Change Order Request #055 APR-30 Slop Sink

Project: LDFM Station 1 Remodel
746 Kentucky Street
Lawrence, KS 66044

Project Name: Fire Station #1 Lawrence Ks **Project #** 2018-046

Project: 18-001 - Fire & Medical Station No. 1
 746 Kentucky 745 Vermont
 Lawrence, Kansas 66044

ROOF PLAN

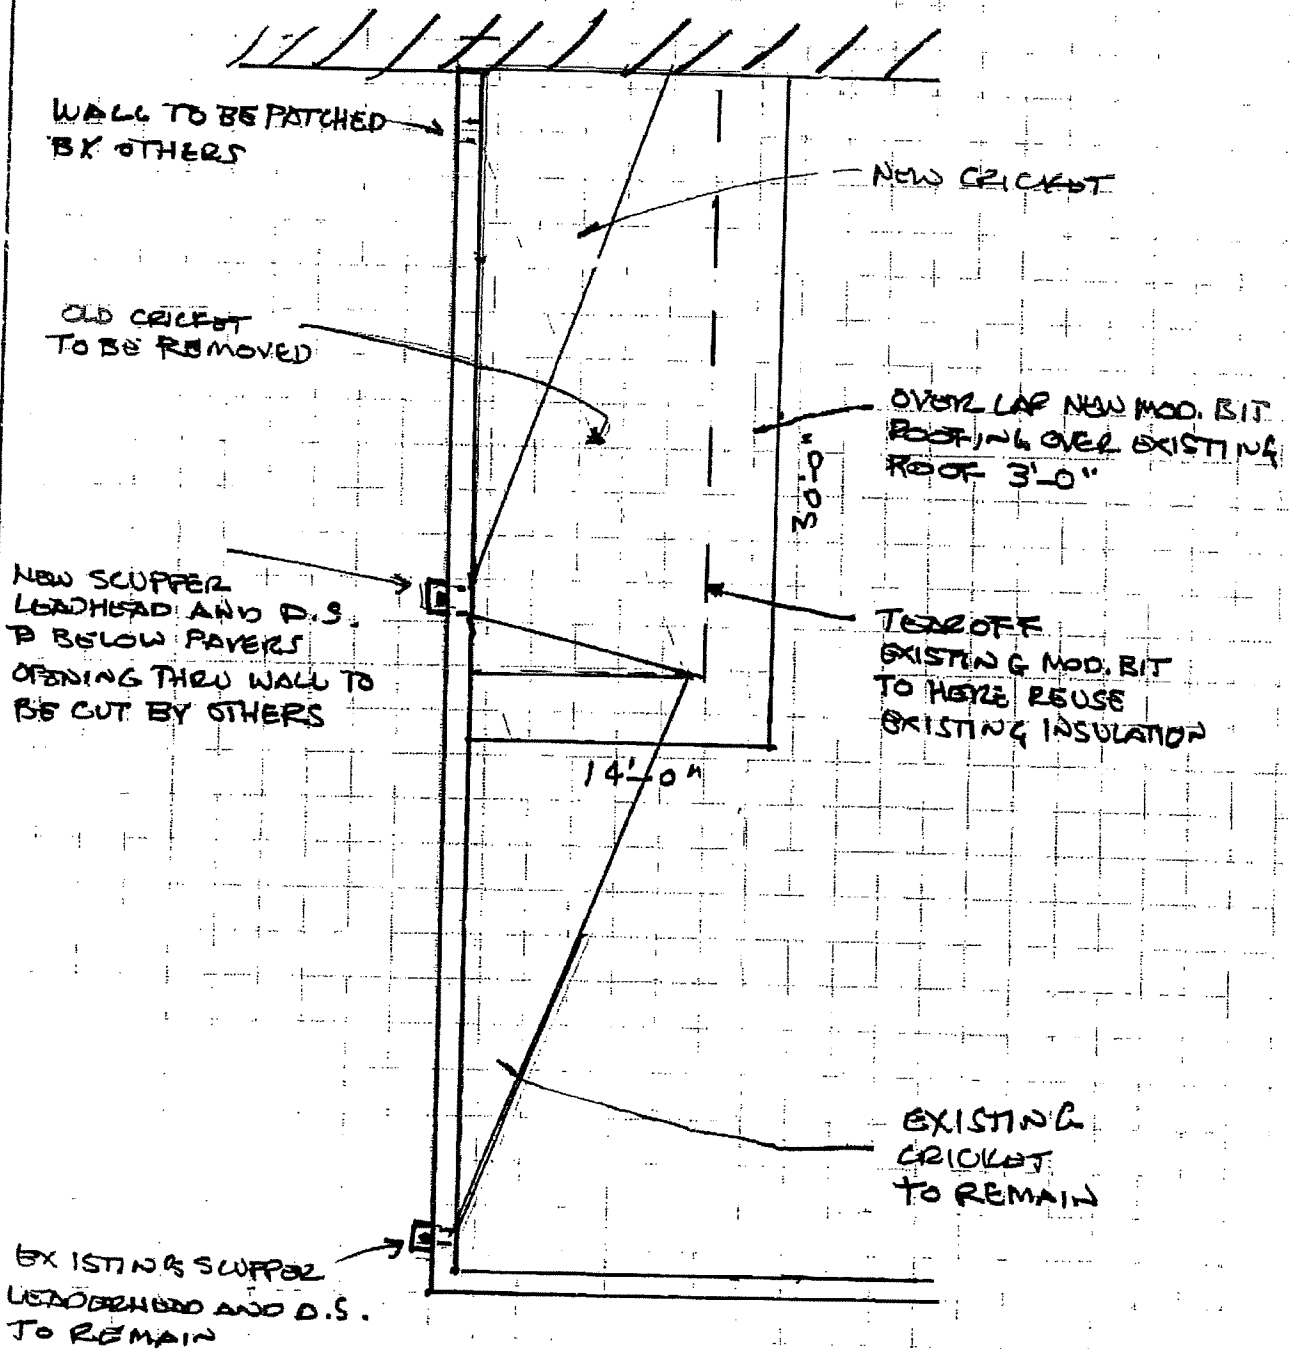
Work in accordance with APR-33 dated 3/22/19 to modify roofing and add a new scupper from the existing apparatus bay roof.

Revised cricket layout. See attachment. The new price is \$5,954.00

STAIR TOWER PARAPET DETAIL **5/A301**
 1-1/2" = 1'-0"

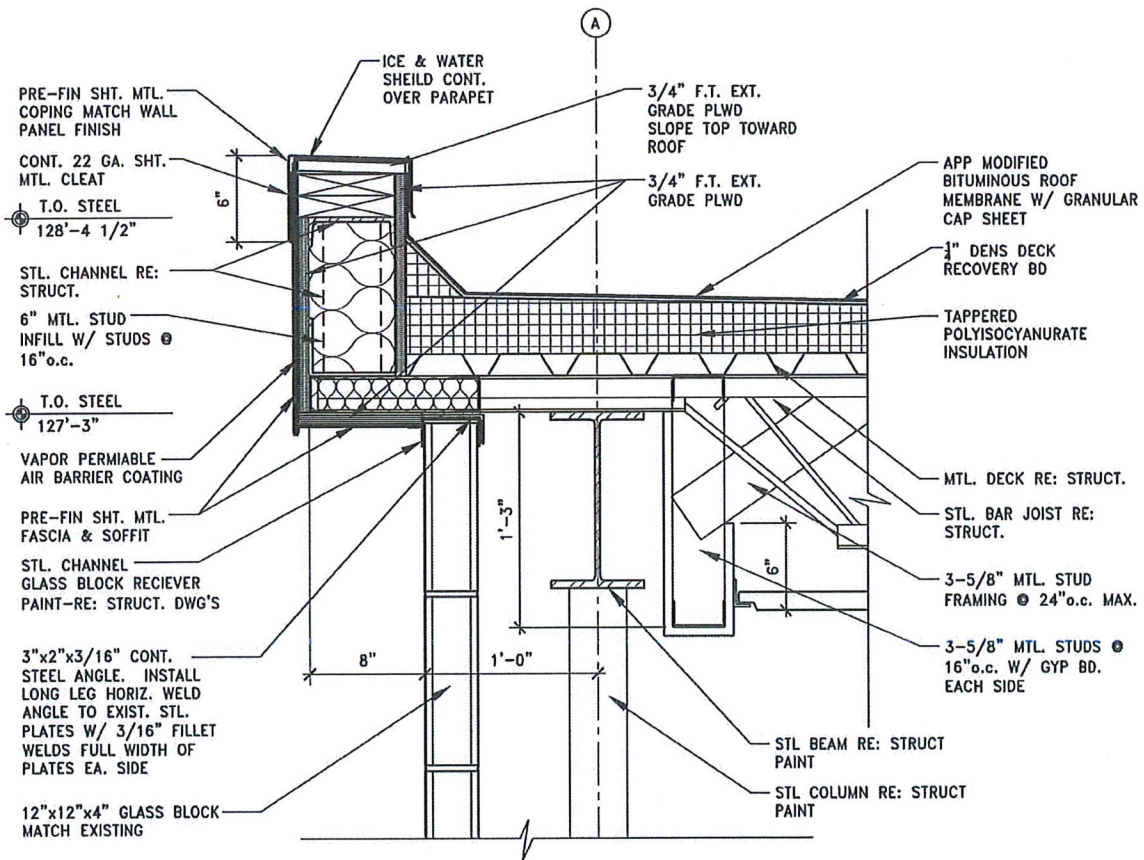
Provide itemized pricing for the following scope of work for additional anchorage at the head of glass block installation:
1. Provide and install continuous 3"x2"x3/16" steel angle at the glass block head condition typical.
2. Weld angle with long leg horizontal to existing steel plates provided on the underside of joist tail extensions typical.

HME to provide (4) 3x2x3/16 angles per APR 38 and email from Tracy Green on 4/15/19. All material to be primed finish only.

- (1) 19'-4" long
- (1) 13'-4" long
- (1) 17'-0"
- (1) 8'-0"
